608 N SUMMERLIN AVENUE LAKE EOLA HEIGHTS HISTORIC DISTRICT

Summary

A Major Certificate of Appropriateness to demolish the existing structure and build a new single family residence with an accessory structure that has a garage and second floor ADU.

PROPOSED SITE PLAN

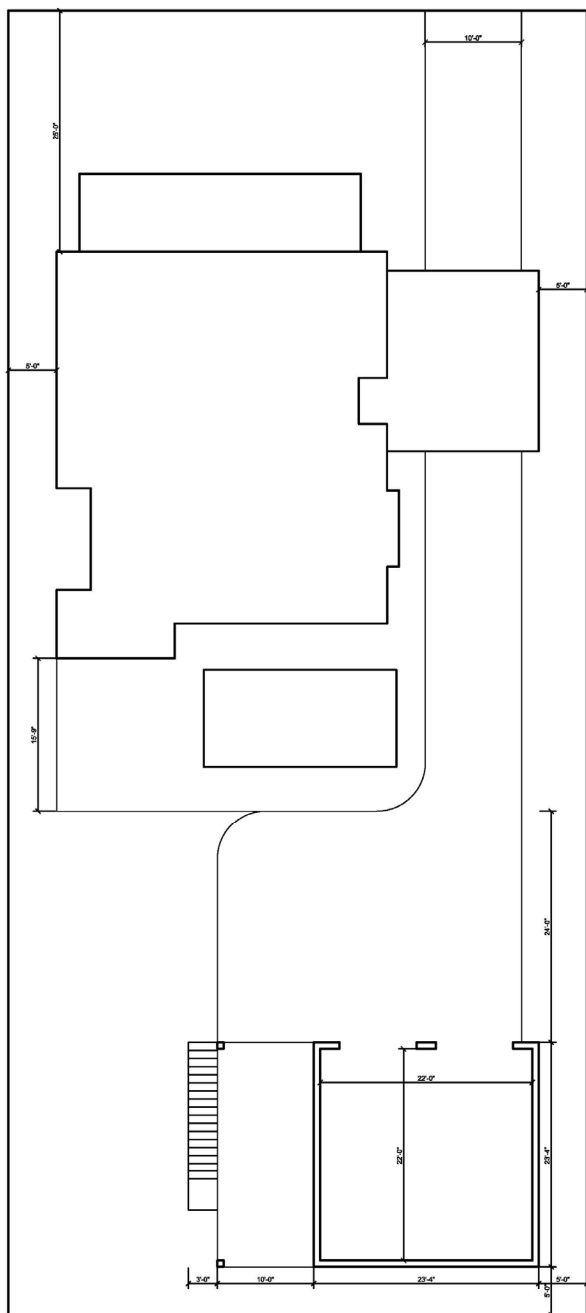
The proposed location of the main structure meets the average front setback for the block. The driveway placement to the south follows the existing pattern of development on the site. However, the accessory structure does not. Historically, the garage would have been at the end of the driveway with the doors facing the street. Staff is recommending the accessory structure be relocated to this placement and then mirrored so the stairs and open parking are on the interior of the lot. This would also minimize the ISR created by elongating the driveway and create space for swales that will be required by storm water engineering.

4. The garage shall be rotated so the overhead doors face the street. The garage shall be placed 5 ft from the south and rear lot lines.
5. The HPB approves a rear setback reduction of 10 feet to allow the accessory structure to be 5 ft from the rear lot line when 15 ft is required .

6. The accessory structure shall be mirrored on the site so the stairs and open parking are located to the interior of the lot.
7. The garage shall have 2 overhead doors with windows in the top panel.

RECOMMENDED SITE PLAN

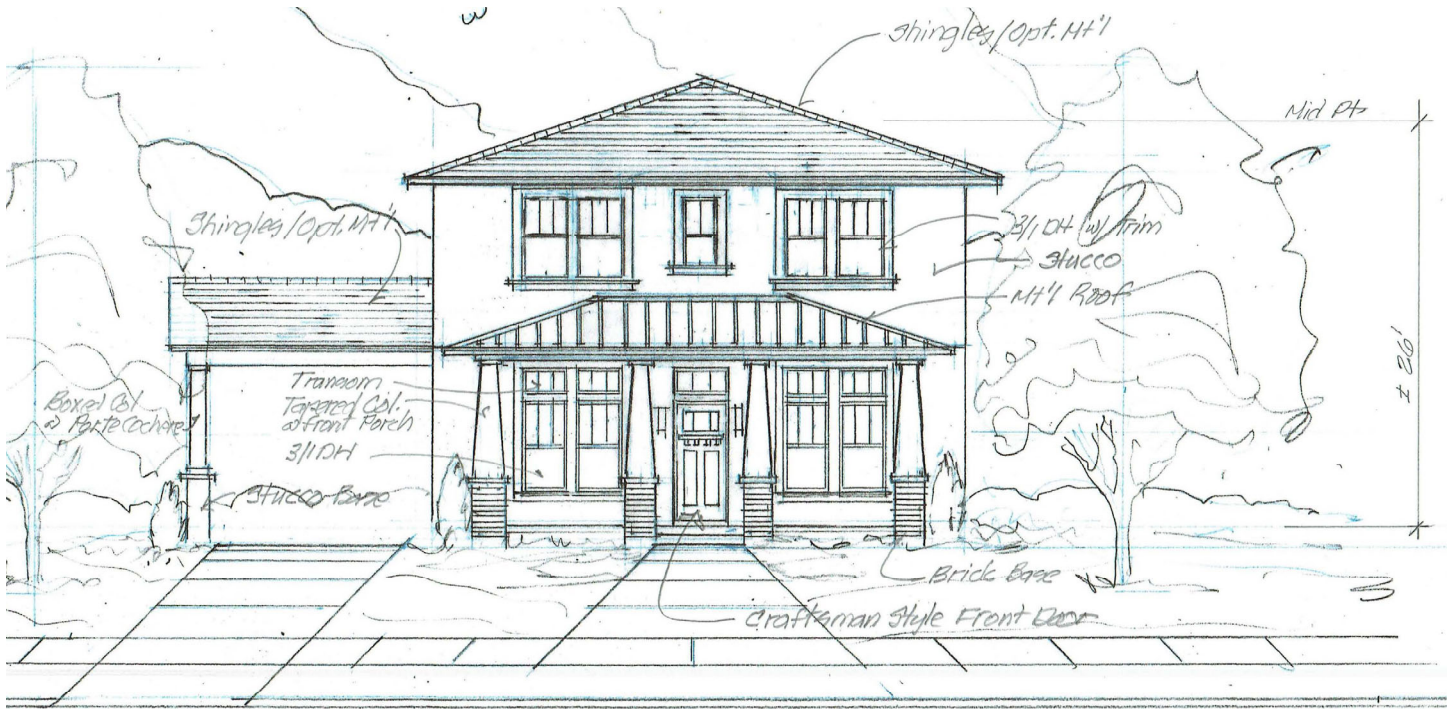
Altering the orientation and placement of the garage allows the site development to follow the historic pattern and does not sacrifice the 3 car garage or the pool. It also provides ample backyard space for water retention.

PROPOSED ELEVATIONS OF HOUSE

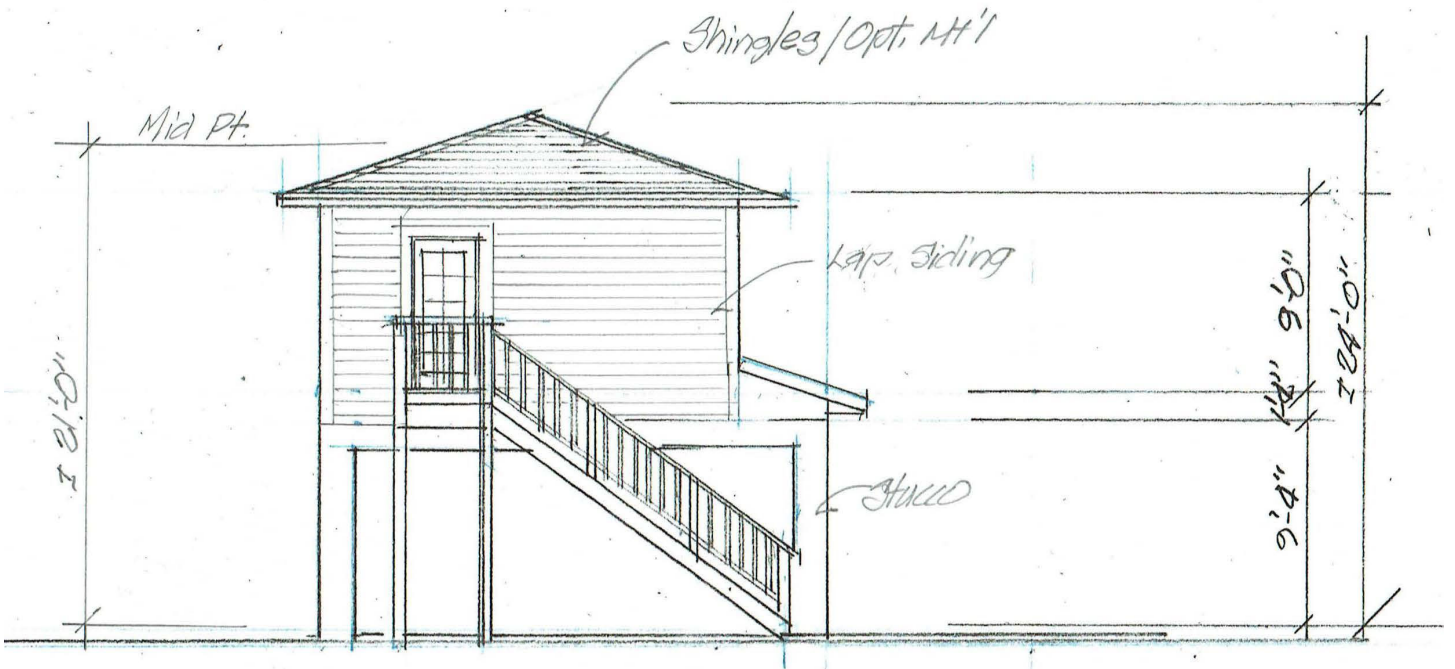
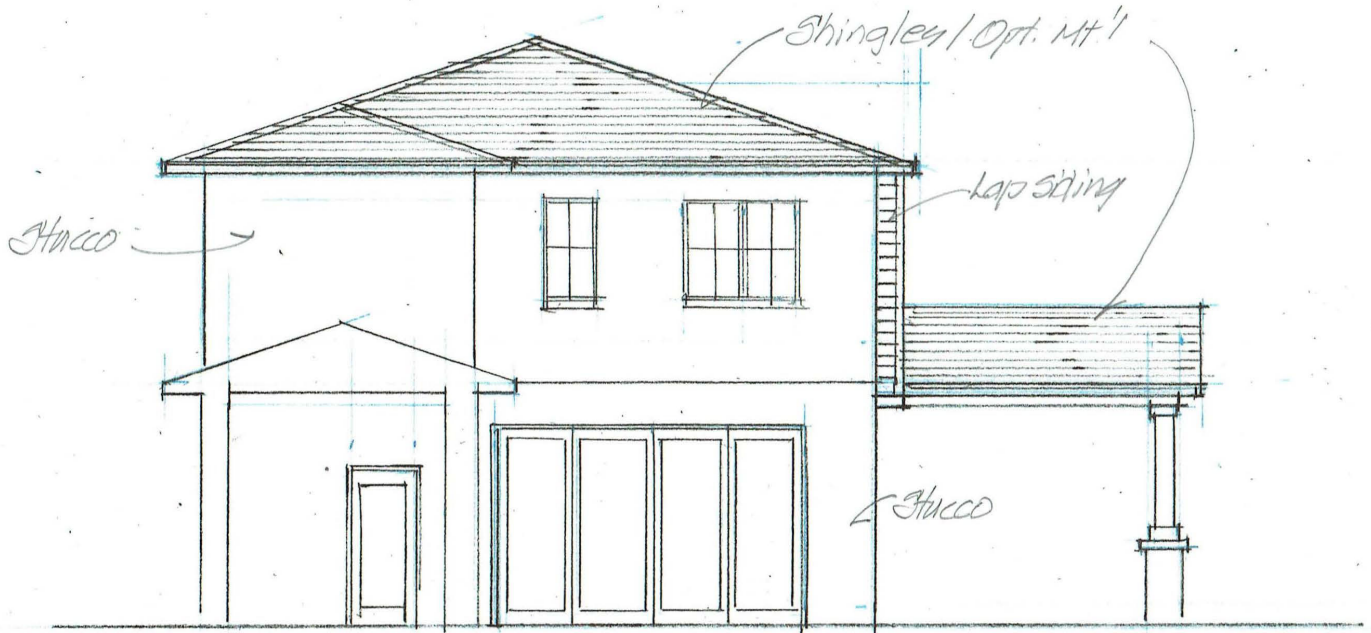
Most of the preliminary comments from staff have been addressed. However, the front façade shows transom windows which are not appropriate on craftsman style homes. The first floor should be at least 18" above the grade. The overall height is given at 26 ft which is lower than the max. allowed by code but staff requested a comparison with adjacent structures and that was not provided. Staff would recommend keeping asphalt shingles on all roof surfaces.

8. The front porch shall be a minimum of 6 ft deep but shall not exceed the 8 ft max. allowable by code.
9. All windows shall be 3 over 1 double hung with trim.

15. The finished floor shall be a minimum of 18" above grade.
16. Final Site plan follows all engineering standards.
 - A. This site is not exempt from substantial enlargement or substantial improvement requirements because it is non-contributing.

PROPOSED SIDE ELEVATIONS OF HOUSE

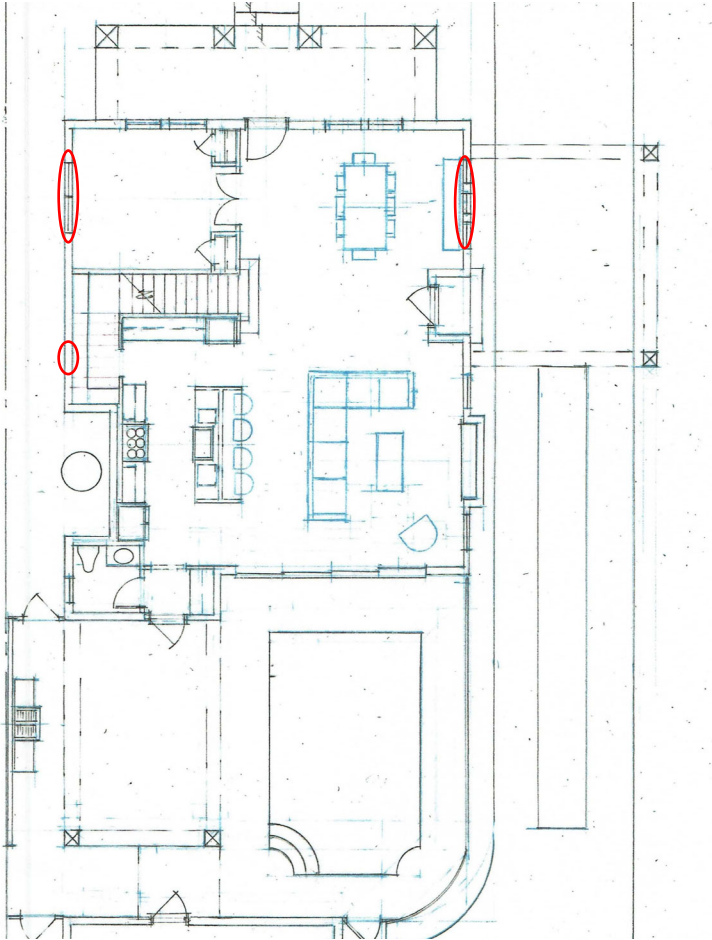
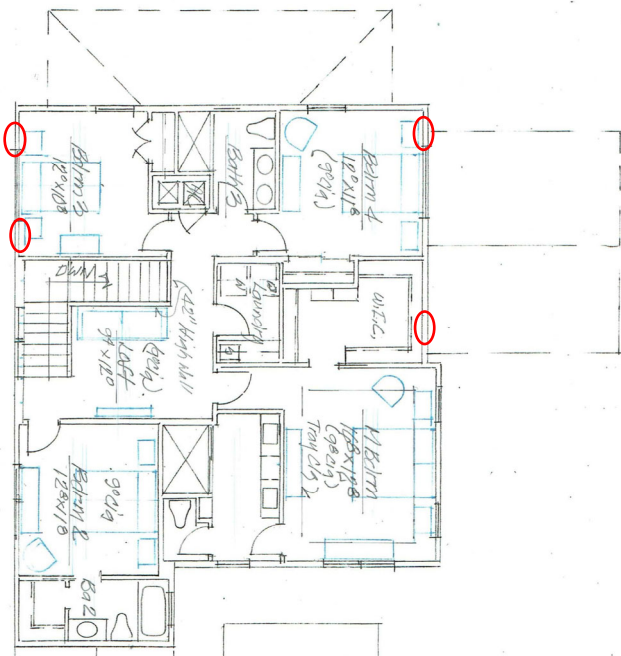
North and South elevation: Staff's preliminary comments were to make sure all windows were shown as 3 over 1 double hung with appropriate trim details. Windows should not be squares as they are required to have a vertical emphasis. The garage overhead doors shall be (2) single doors.

PROPOSED FLOOR PLANS

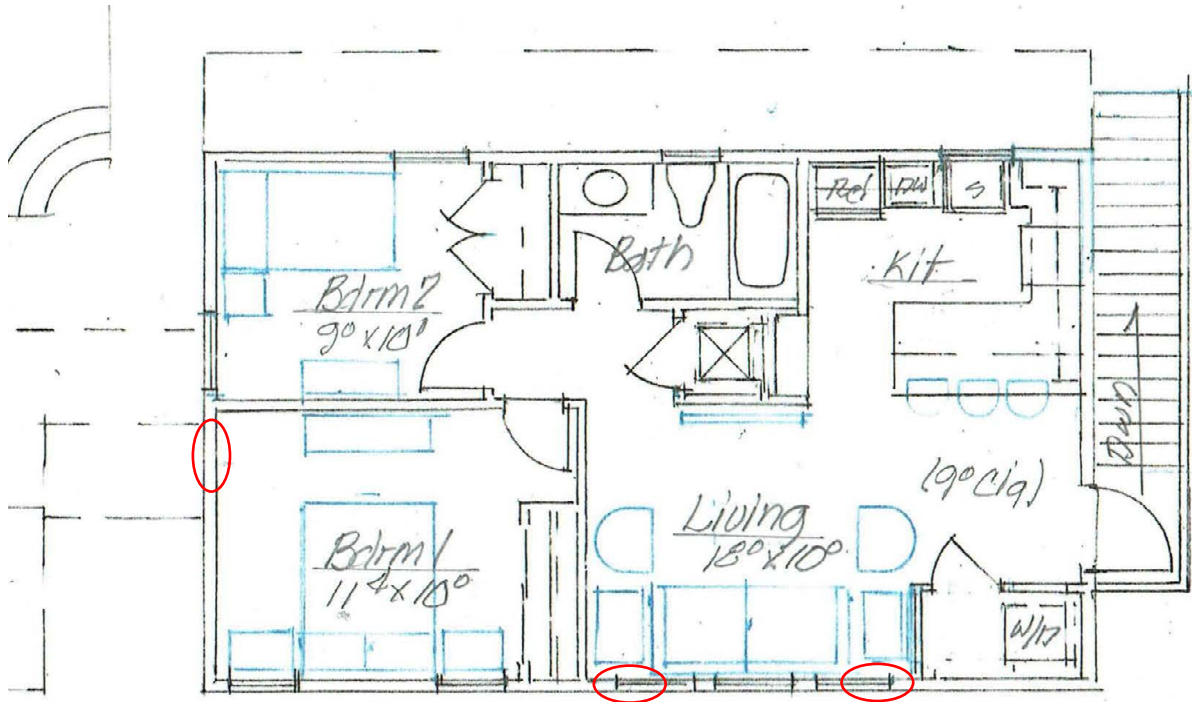
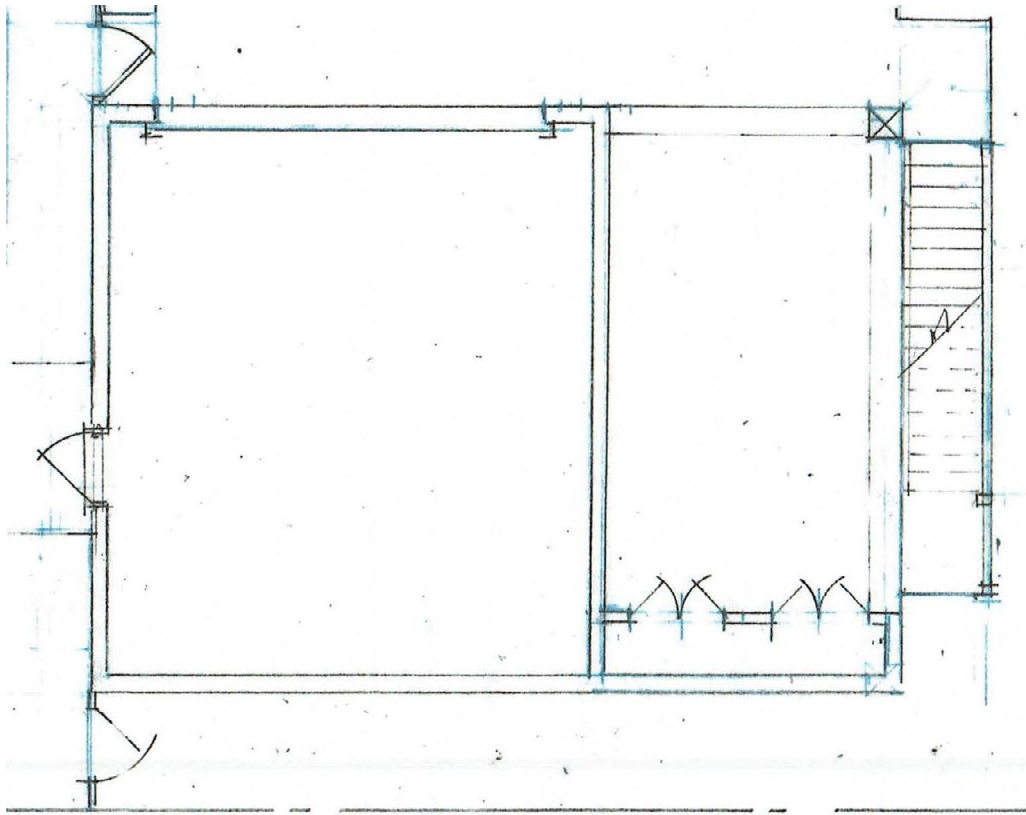
First Floor plan provided by applicant shows that double hung vertical windows can be achieved in various locations.

Second Floor plan showing proposed locations for double hung windows
